Access Compliance Report Public Rights-of-Way (Curb Ramps)

Intersection ID: 28154 Main Street: AUTUMN_APPLAUSE_DR Cross Street: WILLOW_TREE_LN Location: NW

ADA ID: 3E5F0A29E6D9 Ramp Type: PerpDiag Initial Pass/Fail: Fail Overall Compliance: No Severity Score: 18.75

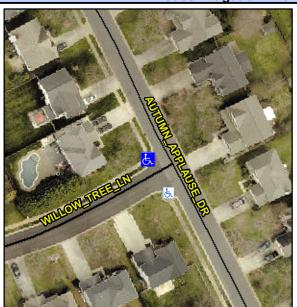
Not Found, R304.5.1, R304.5.3

Field Measurements/Component Compilance					
Compliance Description		Data	Compliance Description		Data
N/A	Ramp Length (in)	96.0	Yes	Ramp Slope (%)	6.0
No	Ramp Width (in)	33.0	No	Ramp XSlope (%)	3.1
N/A	Flare Type LT	N/A	N/A	Flare Type RT	N/A
N/A	Flare Slope LT (%)	N/A	N/A	Flare Slope RT (%)	N/A
N/A	Flare Traversable LT?	N/A	N/A	Flare Traversable RT?	N/A
N/A	Landing Length (in)	N/A	N/A	DWS Provided?	N/A
N/A	Landing Width (in)	N/A	N/A	DWS Contrast?	N/A
N/A	Landing Slope (%)	N/A	N/A	DWS Length (in)	N/A
N/A	Landing X Slope (%)	N/A	N/A	DWS Full Width?	N/A
N/A	Landing Curb? (Y/N)	N/A	N/A	DWS Offset (in)	N/A
N/A	Shared Landing?	N/A			
N/A	Gutter Ponding?	N/A	N/A	Gutter Slope (%)	N/A
N/A	Gutter Lip Ht (in)	N/A	N/A	Gutter X Slope (%)	N/A
N/A	Painted X Walk1?	No	N/A	Painted X Walk2?	No
	X Walk 1 Direction	To S		X Walk 2 Direction	ТоЕ
N/A	X Walk 1 Width (in)	N/A	N/A	X Walk 2 Width (in)	N/A
	X Walk 1 Slope (%)	2.6		X Walk 2 Slope (%)	4.1

Remove & Replace Curb Ramp With Two New Directional Ramps or Equivalent.
